**Bridge Road and Victoria Street Activity Centres
Draft Amendment C291yara**

Yarra Activity Centres Standing Advisory Committee Report 3

24 June 2022

Figure 2 Exhibited Interfaces H and post-exhibited Interface J

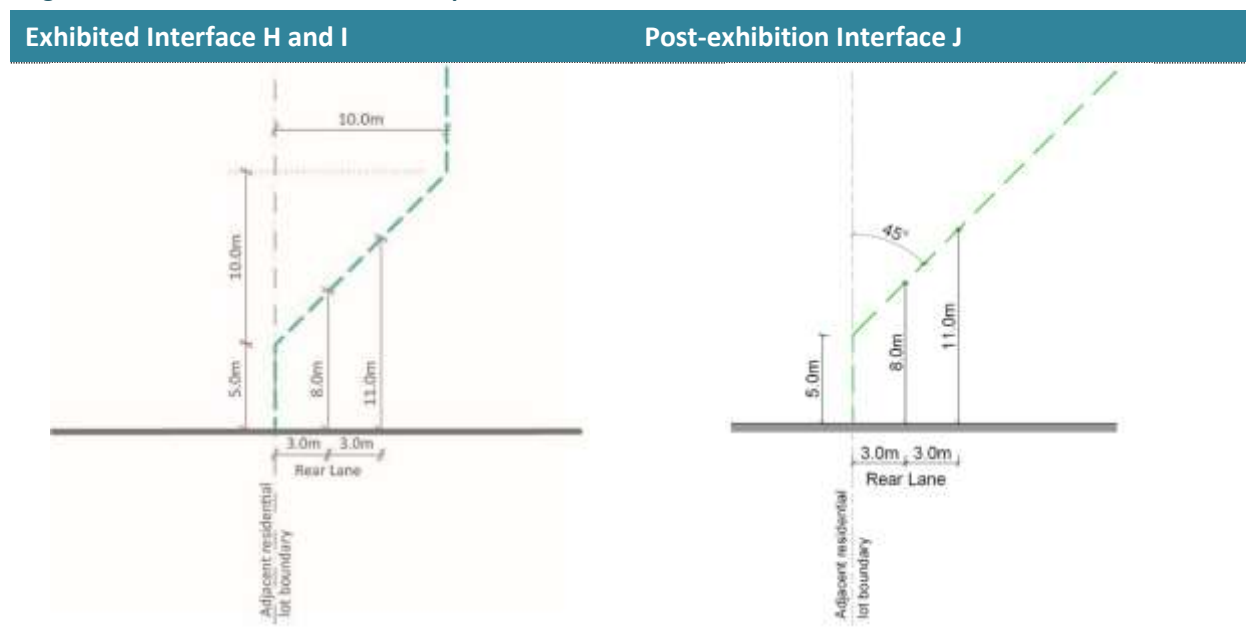
Council advised that, since exhibiting the Amendment, it notified affected people of a new Interface J, as shown in Figure 2 of this report. Prof McGauran explained:

Figure 4 DDO41 Proposed change to Height and Interface Plan for 146 and 148 Bridge Road, Richmond (PMTV Australia Pty Ltd & Keramitsis)

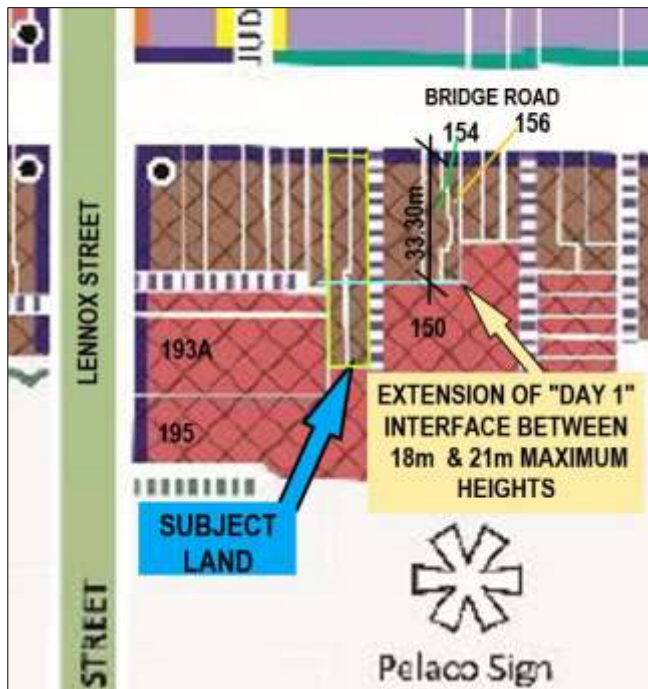
PMTV Australia Pty Ltd and A and C Keramitsis (PMTV) submitted that the rear (south) section of 146 and 148 Bridge Road, Richmond should have a 21 metre mandatory maximum building height, rather than 18 metres as exhibited. They sought to change the DDO41 Plan 1 Height and Interface Plan to show a matching alignment with 150 Bridge Road, Richmond in relation to the height designations. This is shown on Figure 4 below.

PMTV submitted that the extensive depth of lots allowed for generous setbacks and therefore higher built form to the rear without creating visual impacts on the Bridge Road streetscape. PMTV submitted that property boundaries were not permanently fixed and shouldn't in all cases be the principal factor in determining building height provisions. They referred to a current plan of subdivision which had been prepared to subdivide the rear portion of these properties and create a separate parcel with extensive frontage to Wustemenn Place.

The Committee supports a change to the DDO41 Height and Interface Plan to apply a 21 metre mandatory maximum building height to the rear of 146 and 148 Bridge Road as shown in Figure 4. The depth of these lots allow for a higher built form to the rear that would not negatively impact on the heritage streetscape and street wall along Bridge Road and would be consistent with higher built form permitted on either side of these properties. The Committee agrees that property boundaries should not be the sole determinant of proposed maximum building height provisions. In this case, that it is appropriate to have a different height at the front of the site to the rear of the site, and that site context and consideration of the DDO41 objectives are significant factors influencing the application of provisions.

Figure 5 DDO41 Proposed changes to Height and Interface Plan for land in Allowah Terrace and at 193 and 193a Lennox Street (G Kyriakopoulos)

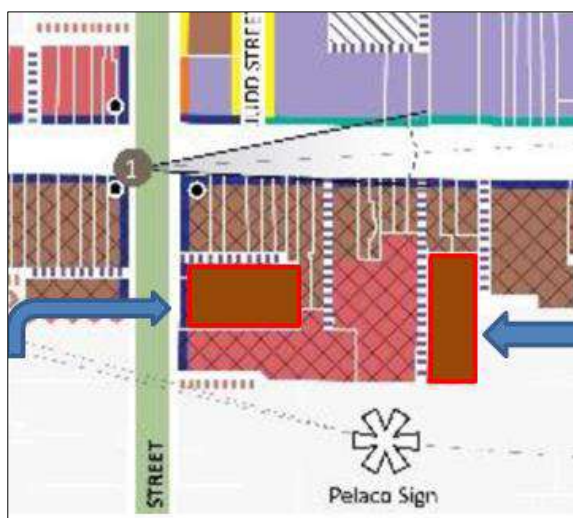
Ms Kyriakopoulos submitted that a mandatory maximum building height of 18 metres, or preferably 16.5 metres, would be appropriate for 193 and 193a Lennox Street, Richmond to protect the heritage character of the Richmond Hill Precinct and to reduce potential impacts on views to the Pelaco building and sign.

Figure 12 DDO48 Plan 2 (Access and movement plan)

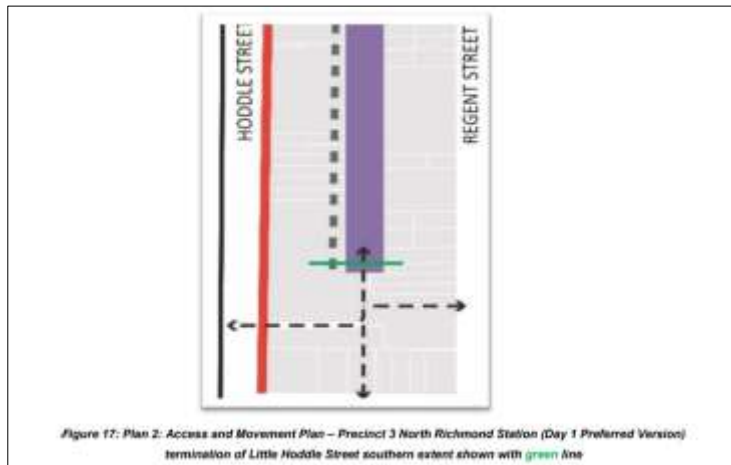
Beresford submitted that DDO48 Plan 2 (Access and movement plan) included an error because the graphics depicting 'Potential Future Shared Zones' extend past the southern end of Little Hoddle Street into Beresford's private property by approximately 4.7 metres. Beresford said:

The 'Plan 2: Access and Movement Plan' must be amended to reflect the termination of the southern end of Little Hoddle Street at the property boundary of the Beresford Land as shown with a green line in Figure 17. It is inappropriate to extend a potential future shared zone into private property.

- e) correct Plan 2 (Access and movement plan) to terminate the southern end of Little Hoddle Street at the property boundary of 67-81 Hoddle Street and 84 Regent Street, Richmond.**

Council agreed that DDO48 Plan 2 (Access and movement plan) included an error and required correction.

Plan 1: Height and Interface Plan – Precinct 1 Bridge Road West

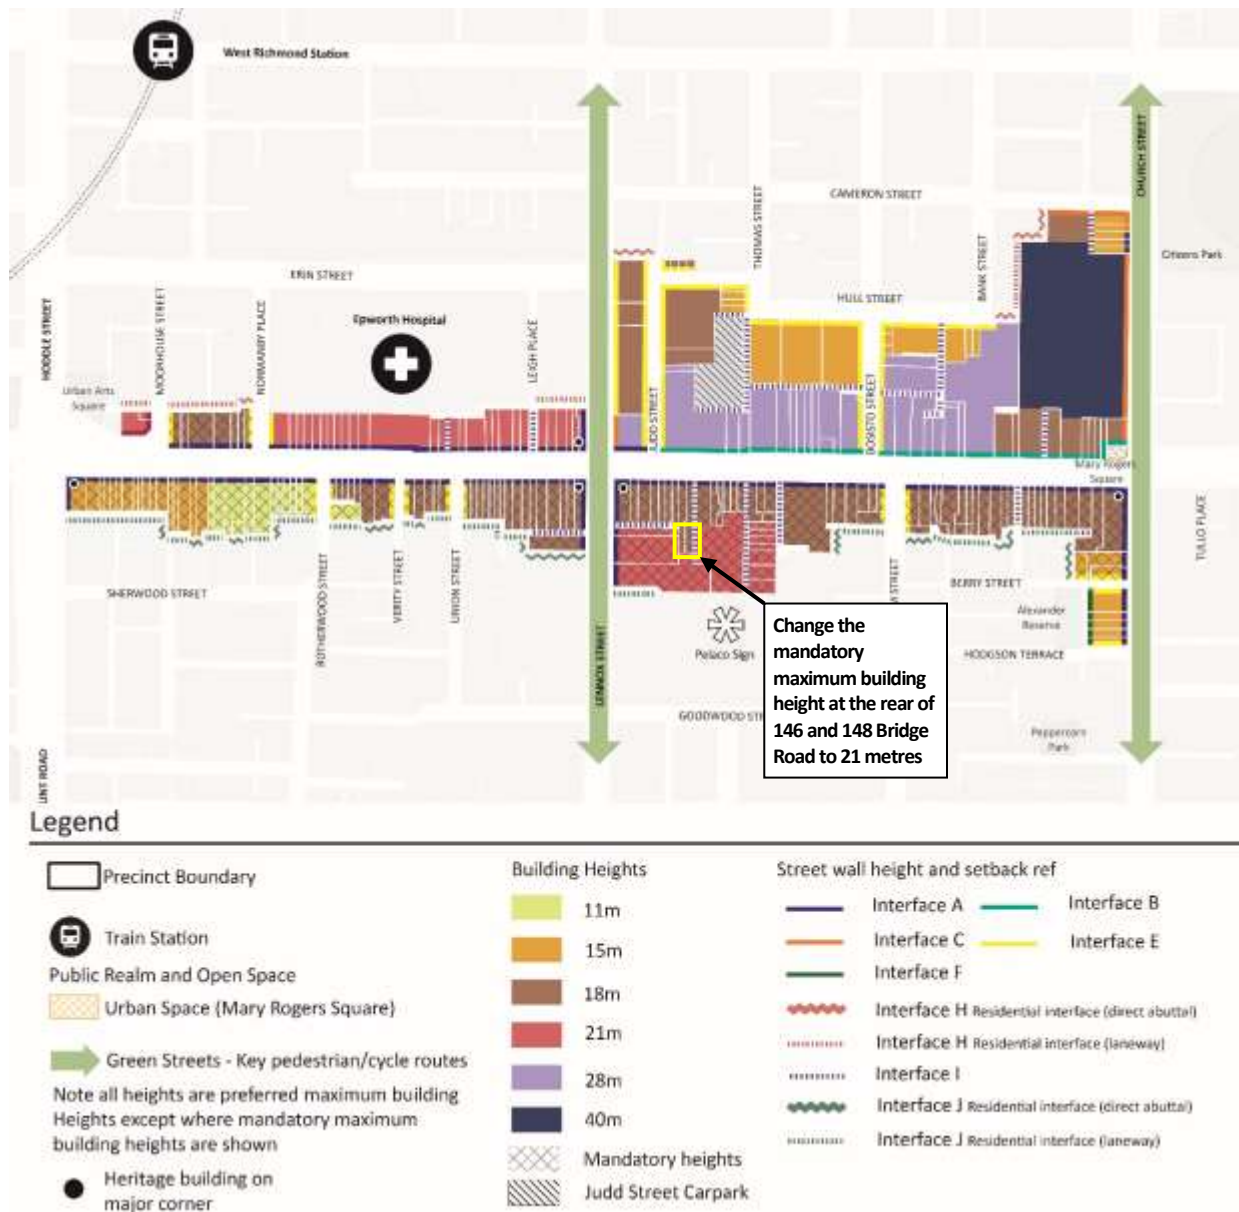
Delete Plan 1 (Height and interface plan) and replace with below

- b) change the mandatory maximum building height across the rear of 146 and 148 Bridge Road, Richmond
 - c) clarify mapping of Interface J near 242 Bridge Road, Richmond

Plan 2: Landmarks Plan – Precinct 1 Bridge Road West

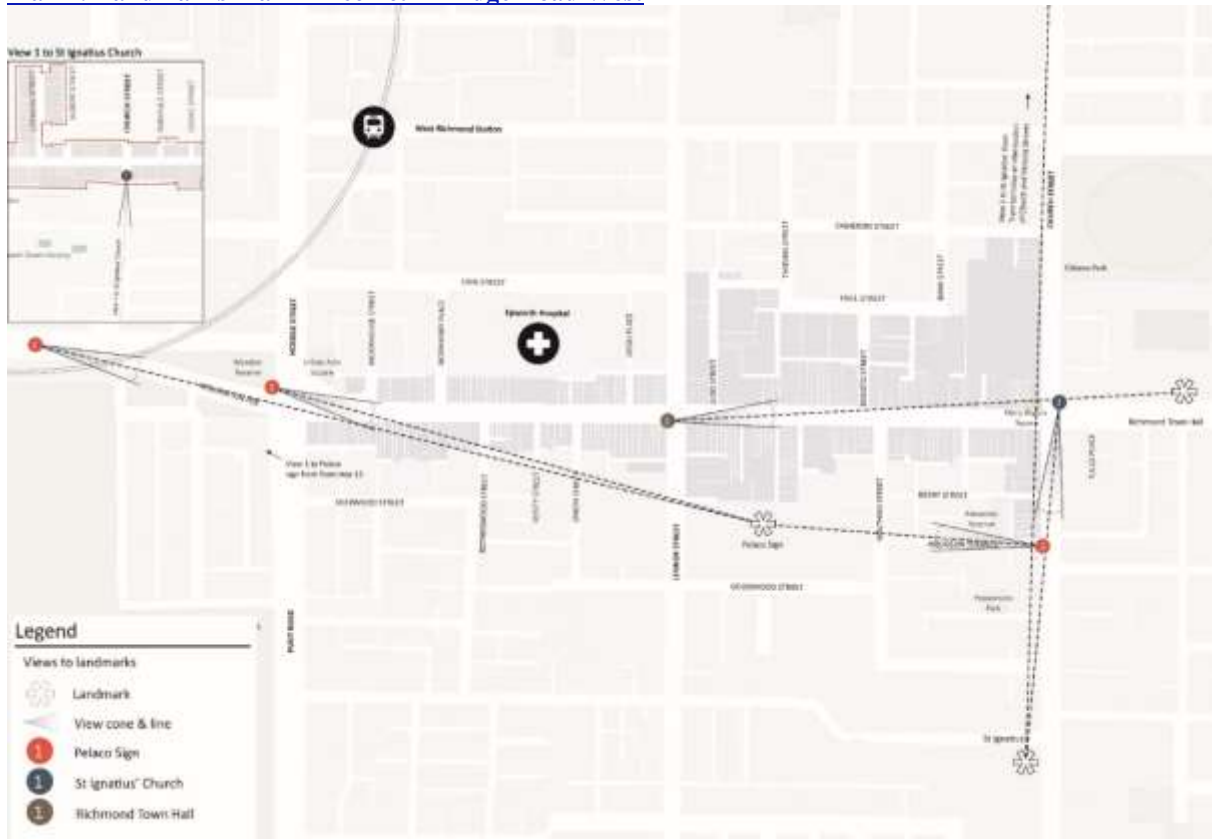
Create new Plan 2 (Landmarks Plan)

- d) clarify overshadowing provisions.
8. Amend the Design and Development Overlay Schedules 41, 42 and 43 to show the correct location and associated view cone of St Ignatius Church.

Plan 2: Access and Movement Plan – Precinct 4 Bridge Road East South

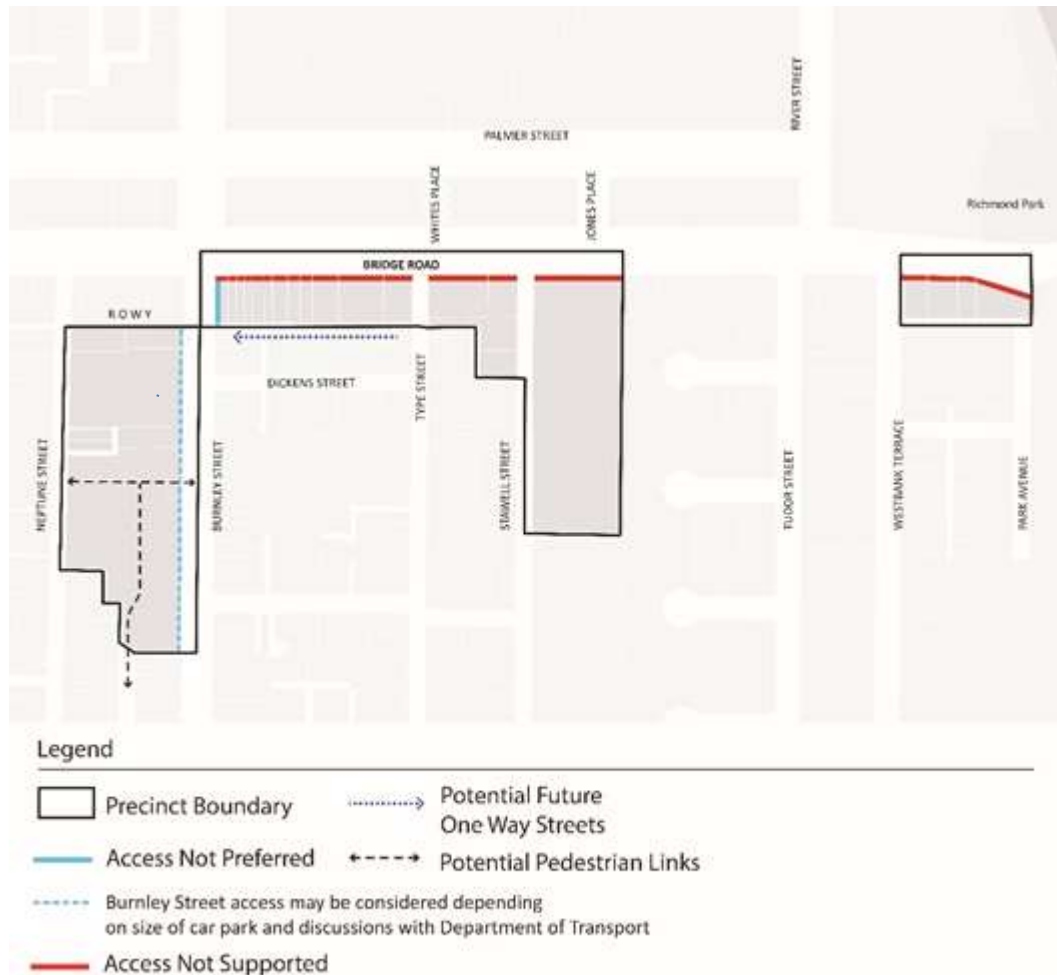
Delete and replace Plan 2: Access and Movement Plan

The potential pedestrian link through 566 Bridge Road as shown on Plan 2 (Access and movement) in Design and Development Overlay Schedule 44 should be removed because it would not allow for the creation of a public thoroughfare.

- d) remove the potential pedestrian link from 566 Bridge Road, Richmond.**

Figure 1 to Schedule 44 – Interface J – to residential properties in NRZ or GRZ

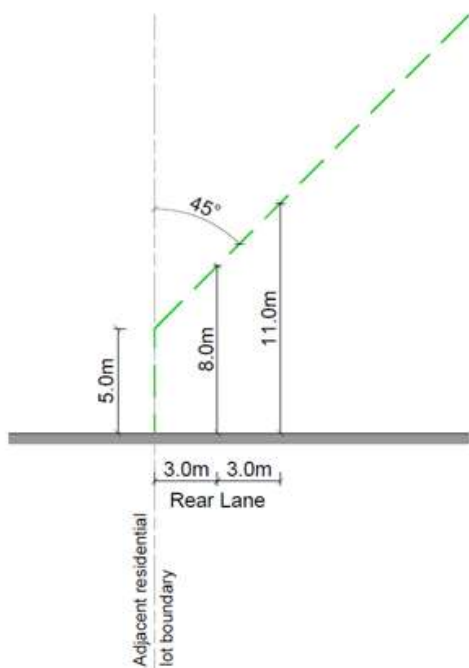
Delete Figure 1 (Interface H) and replace with below

Plan 1: Height and Interface Plan – Precinct 3 North Richmond Station

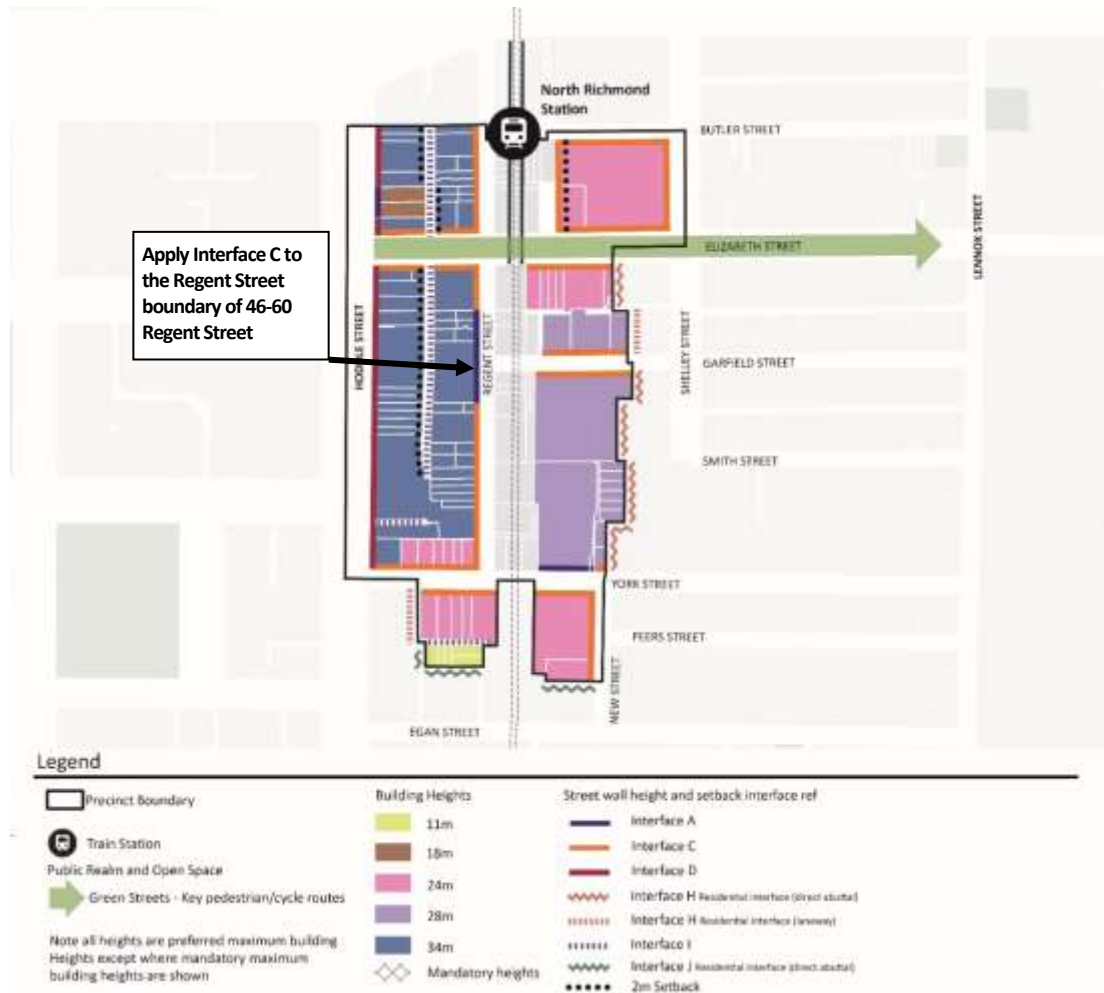
Delete Plan 1 (Height and interface plan) and replace with below

- b) revise the preferred upper-level setback (Interface D) along Hoddle Street south of Elizabeth Street to 3 metres, except within 5 metres of a heritage property where an upper-level setback should be 6 metres**

- c) revise the preferred upper-level setback along Elizabeth Street (Interface C) between Hoddle Street and Little Hoddle Street to 3 metres**
 - d) apply Interface C to the Regent Street boundary of 46-60 Regent Street**

Plan 2: Access and Movement Plan

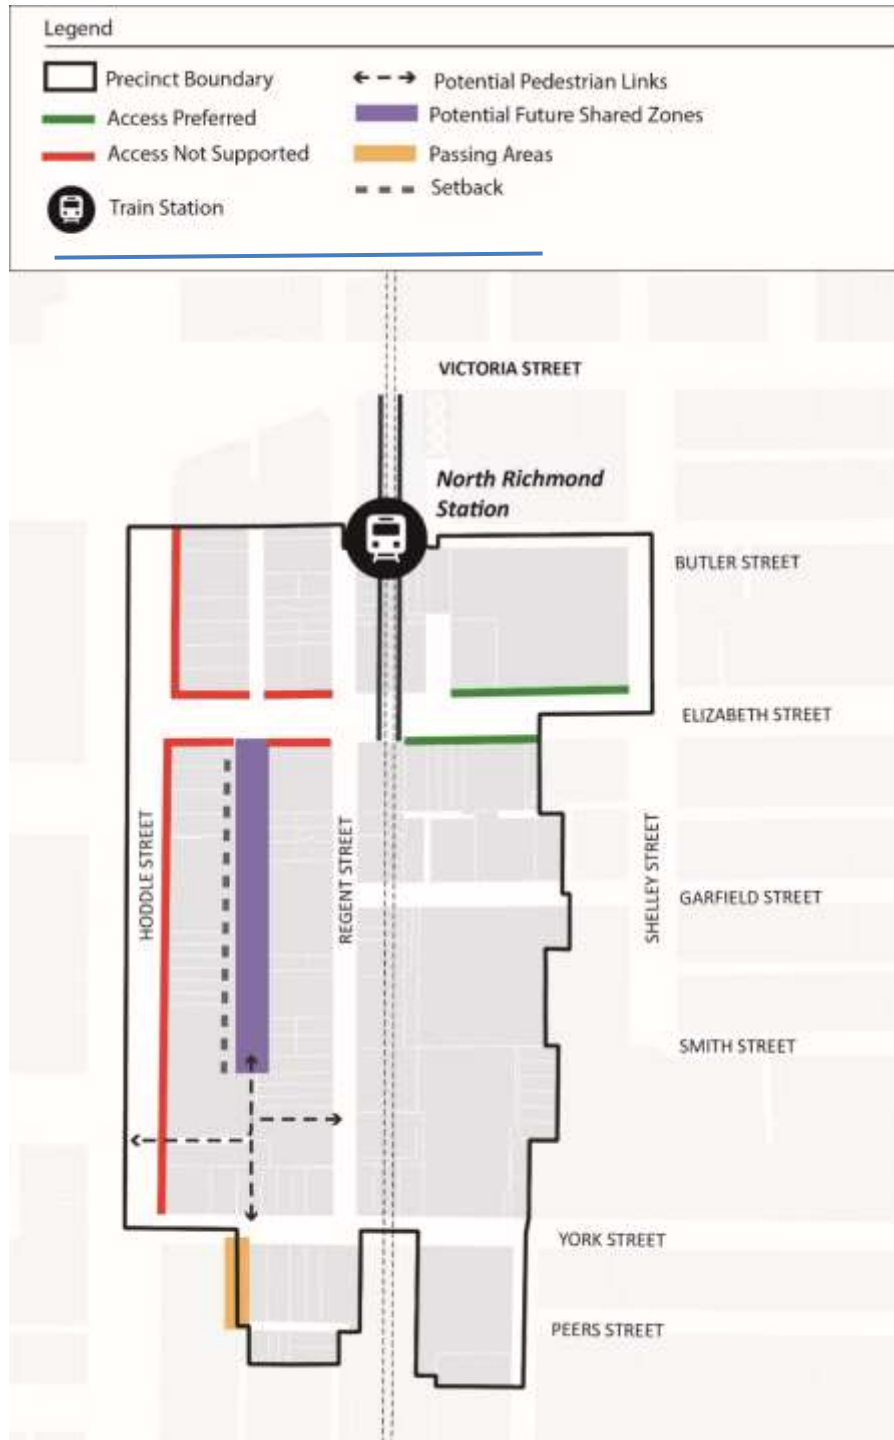
Delete Plan 2 (Access and movement plan) and replace with below

Plan 1: Height and Interface Plan – Precinct 4 Victoria Street East

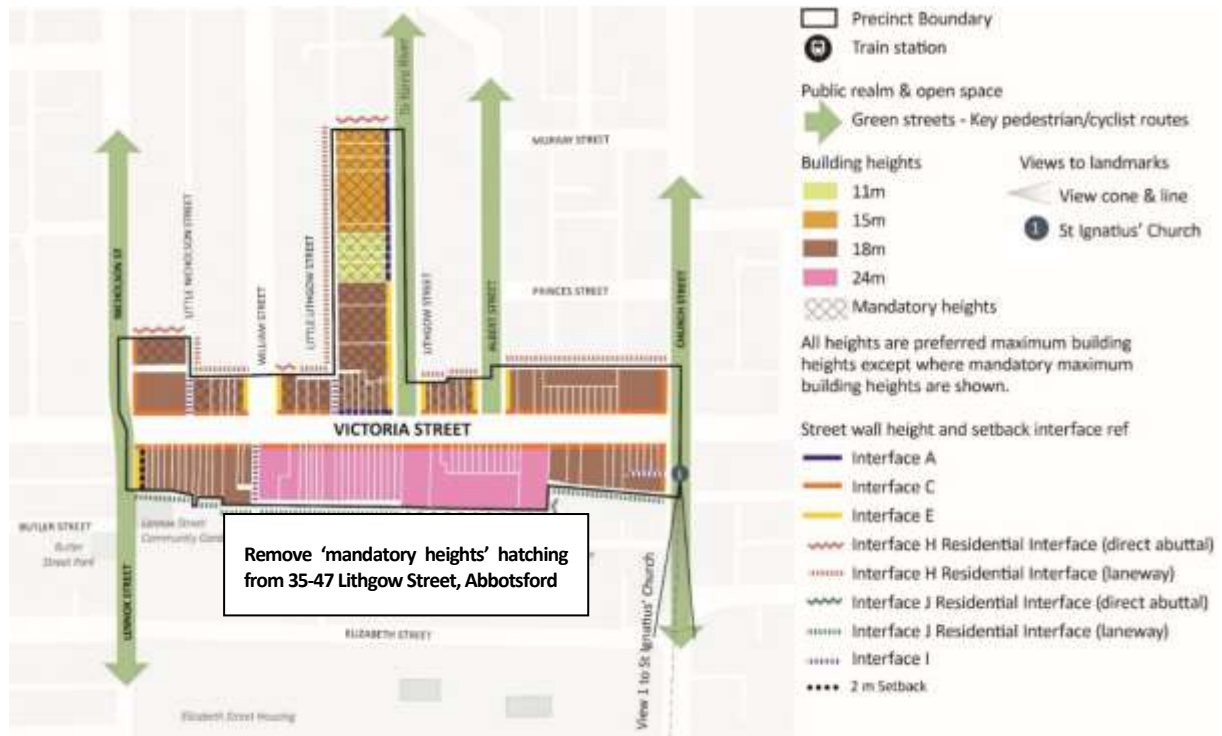
Delete Plan 1 (Height and interface plan) and replace with below

- 14. Amend Design and Development Overlay Schedule 49, as shown in Appendix F4, to change the mandatory maximum height for 35-47 Lithgow Street, Abbotsford to a discretionary height provision.**

Plan 2: Access and Movement Plan – Precinct 4 Victoria Street East

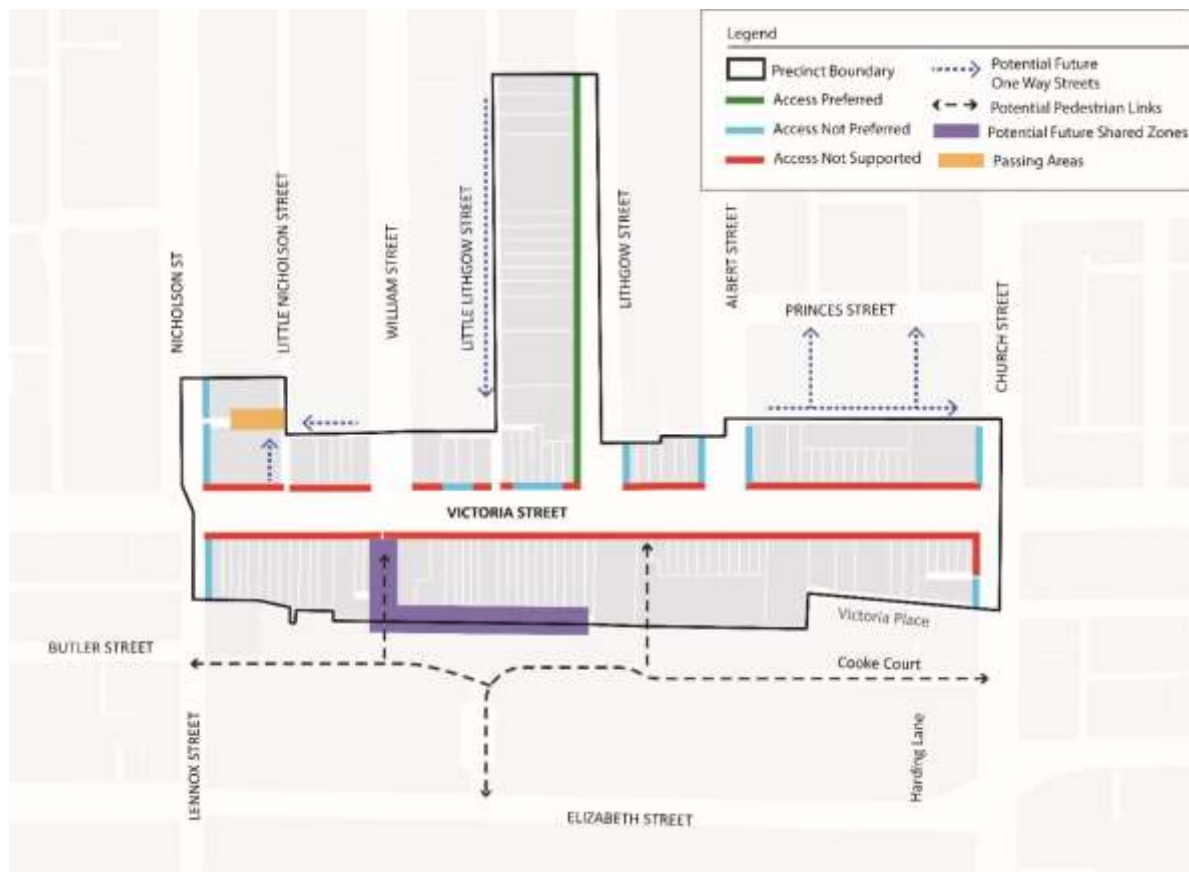
Delete Plan 2 (Access and movement plan) and replace with below
